Federal Hotel

34 - 42 Inglis Street, Mudgee NSW

BCA Fire Safety Upgrade Report

Report 2024/1221 Revision 1.1

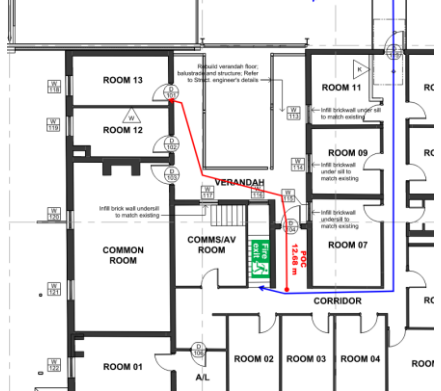
C4D12 (C3.11)	Bounding construction: Class 2, 3, 4 and 9 buildings Travel via an open balcony.	<p>Rooms 13 and Room 12 located on level 01 requires occupants seeking egress without a choice in travel in different directions and passes the external wall of other SOUs containing openings.</p> <p>The openings are required to be a minimum height of 1.5 m above the FFL of the open verandah.</p>	No Reduction in Fire Safety	<p>The Fire Engineering Strategy Report is to demonstrate that the necessity to egress past unprotected openings does not adversely affect the evacuation of occupants from the Level 01 staff accommodation.</p>
